SPD1000X Over Current Protection (OCP) function added in Firmware Revision 2.1.1.9

March 16, 2022

Over Current Protection (OCP) has been added to the SIGLENT SPD1000X series of single-channel power supplies with the SPD version 2.1.1.9

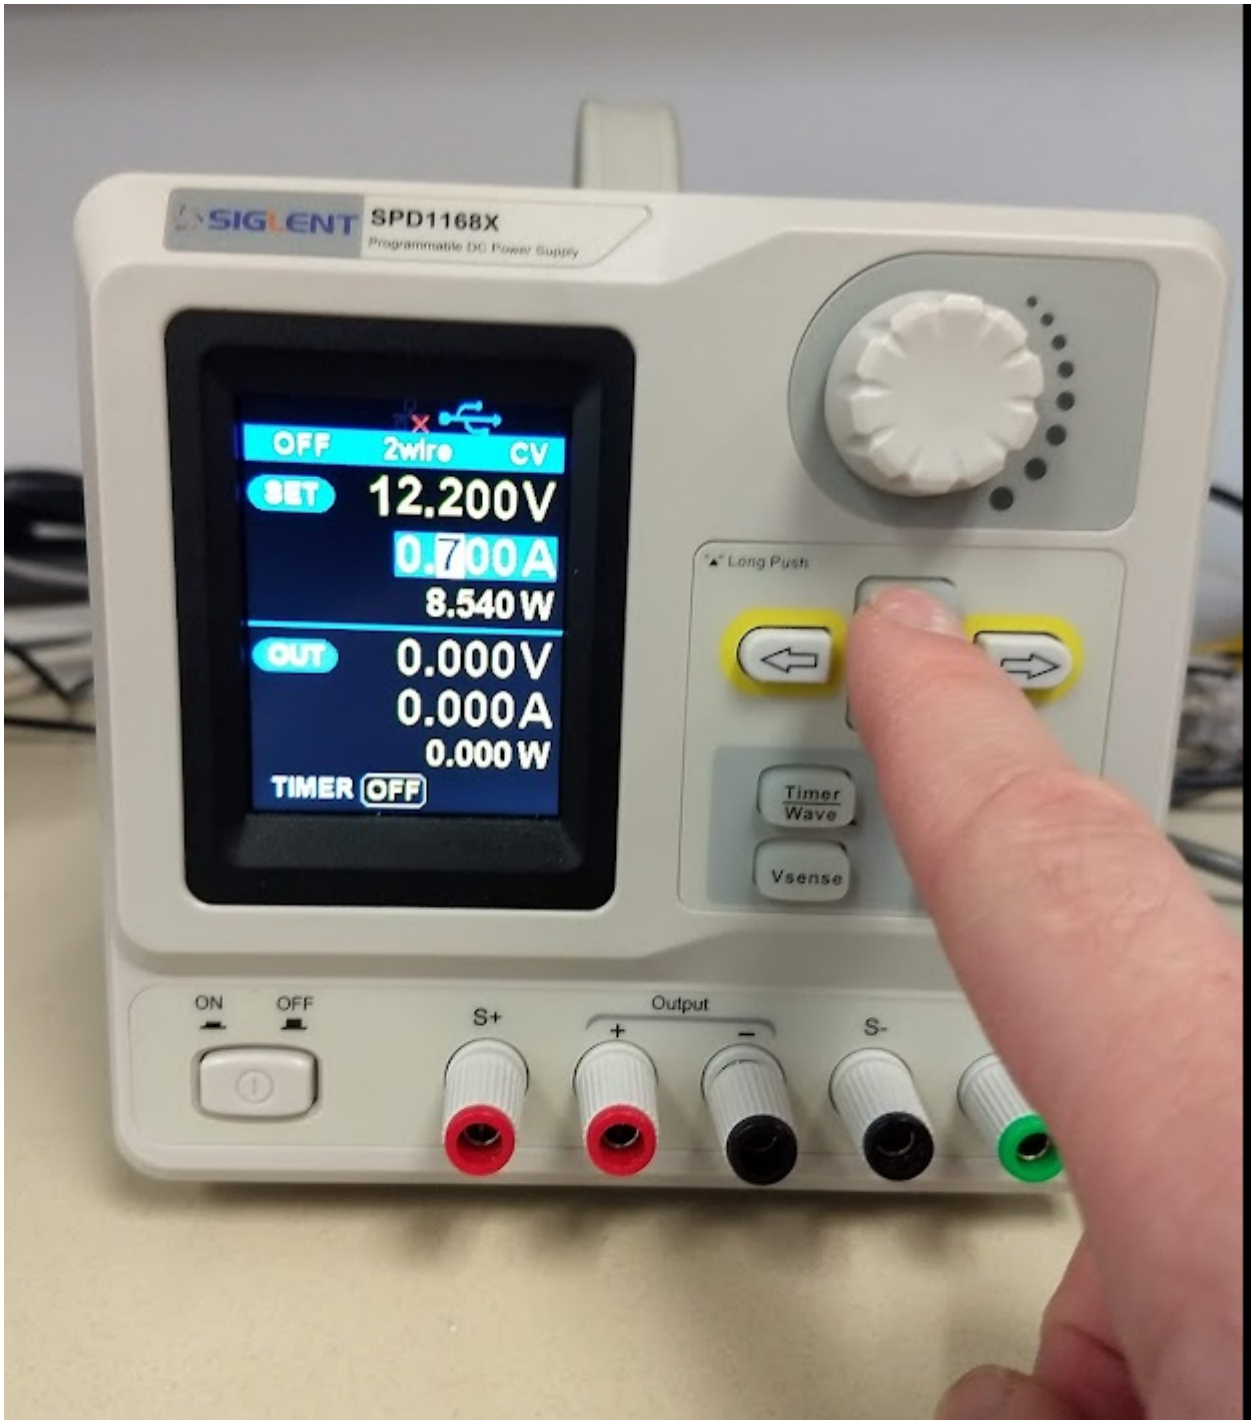
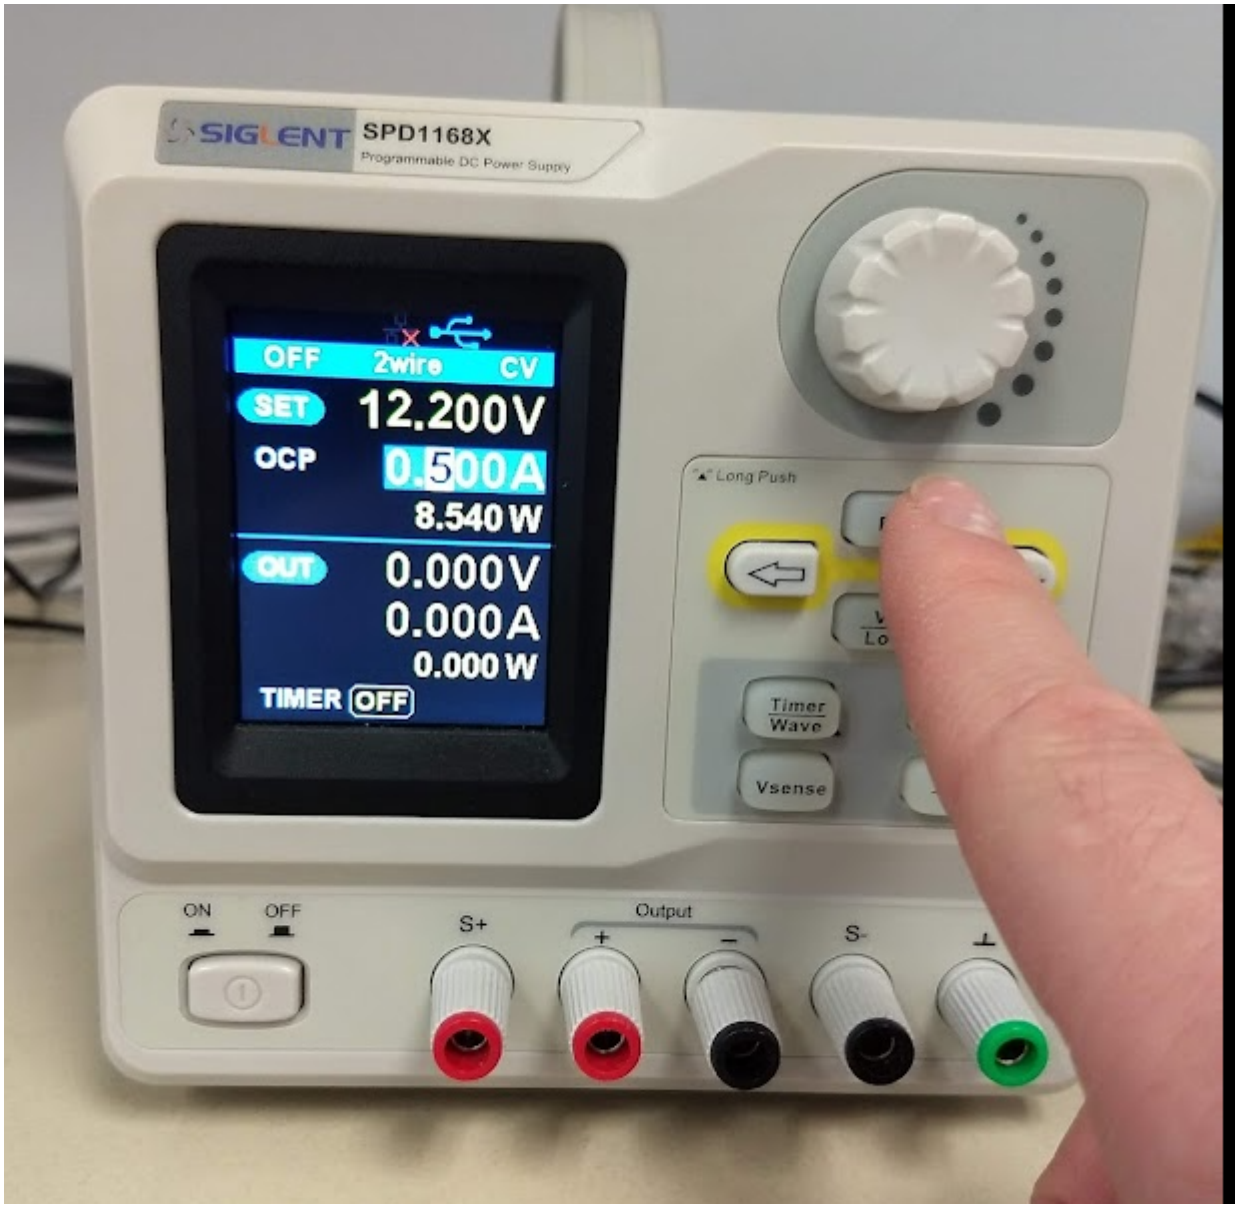
1. Update the firmware
2. Set the OCP value by pressing and holding the FINE button on the front panel. After a few seconds, the OCP label will appear:

3. Set the OCP current value using the knob and right/left arrows to adjust.

4. Long press the FINE button to remove the OCP menu selection.

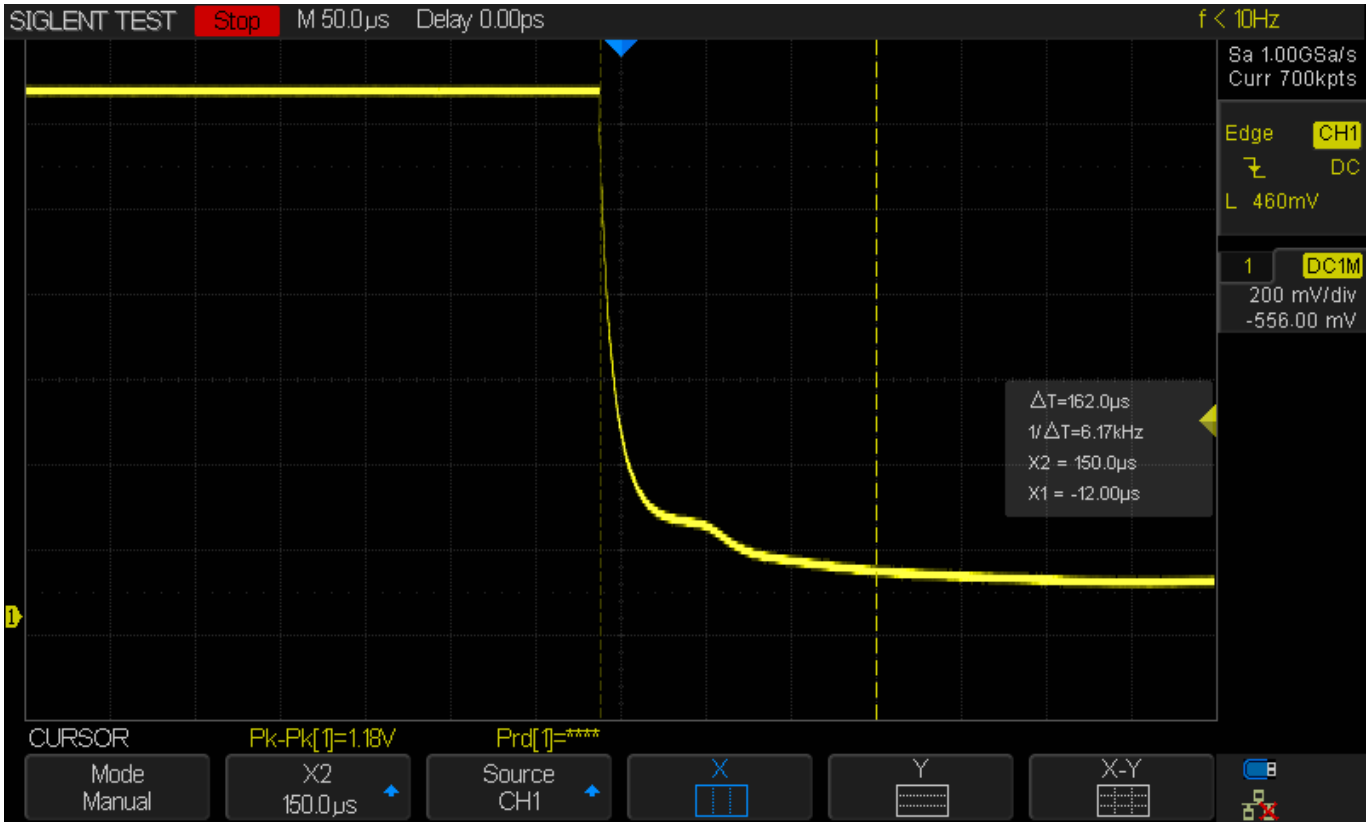
Here is an oscilloscope trace showing a shorted output causing an overcurrent situation (OCP triggered):
